HISTORIC AND DESIGN REVIEW COMMISSION

April 18, 2018

HDRC CASE NO: 2018-156
ADDRESS: 504 AUSTIN ST
LEGAL DESCRIPTION: NCB 510 BLK 2 LOT A-2
ZONING: D, HS
CITY COUNCIL DIST.: 2
LANDMARK: La Fama Bakery, Alt House, Rear House
APPLICANT: Chris Gill/CGRE LTC CO
OWNER: Chris Gill/CGRE LTC CO
TYPE OF WORK: Construction of a rear addition, construction of a rooftop addition, painting and Historic Tax Certification
APPLICATION RECEIVED: April 02, 2018
60-DAY REVIEW: June 01, 2018
REQUEST:

STOREFRONT SYSTEM CURRENTLY BEING INSTALLED - PROFILE AND MATERIALS ARE INCONSISTENT

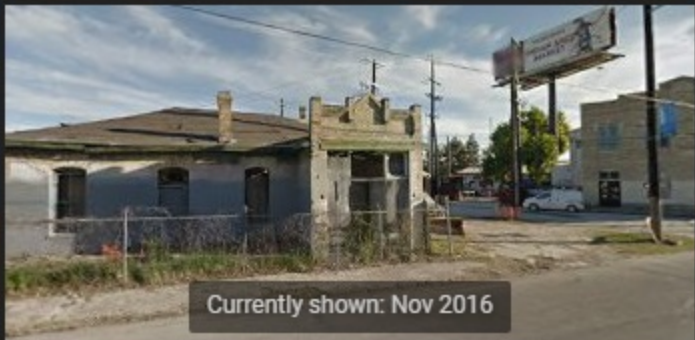
Staff performed a site visit on April 13, 2018, and found scopes of work including roofing, storefront system installation, roof decking installation and exterior modifications being performed inconsistently with previous approvals. The profile and materials of both the storefront system and roofing are inconsistent with previous approvals. Additionally, the profile of the proposed roof deck is inconsistent with previous approvals.

- v. That inconsistencies in current scopes of work related to storefront systems, roof decking, exterior modifications and roofing be corrected to match all previous approvals in regards to materials, architectural profiles and details.

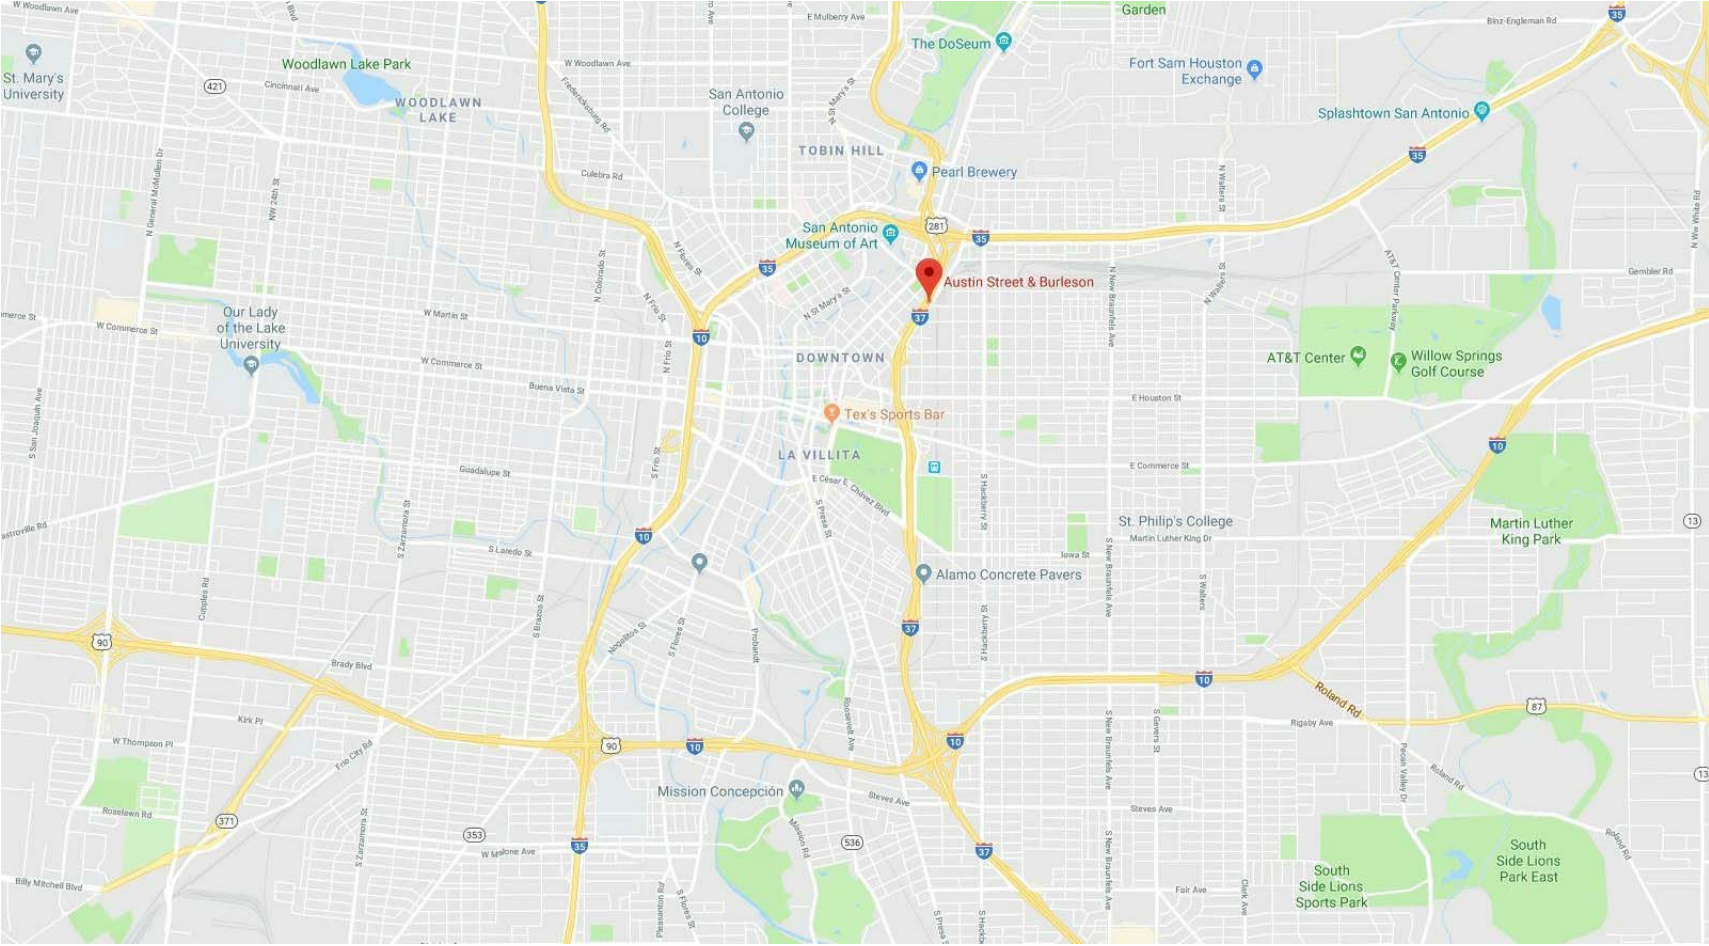
ROOF DECKING IS INCONSISTENT WITH CURRENT AND PREVIOUSLY APPROVED CONSTRUCTION DOCUMENTS AND STIPULATIONS THAT NOTED NO NEW ROOF STRUCTURE WAS TO BE VISIBLE FROM THE PUBLIC RIGHT OF WAY.

**PREVIOUSLY APPROVED ROOFING INCLUDES ONLY
SHINGLES - NO STANDING SEAM REPLACEMENT HAS
BEEN APPROVED - THE INSTALLED RIDGECAP IS
INAPPROPRIATE.**

- ii. That the roofing material be submitted to staff for review and approval prior to installation. Standing seam metal roofs should feature panels that are 18 to 21 inches wide, seams that are 1 to 2 inches in height, a crimped ridge seam and a standard galvalume finish.
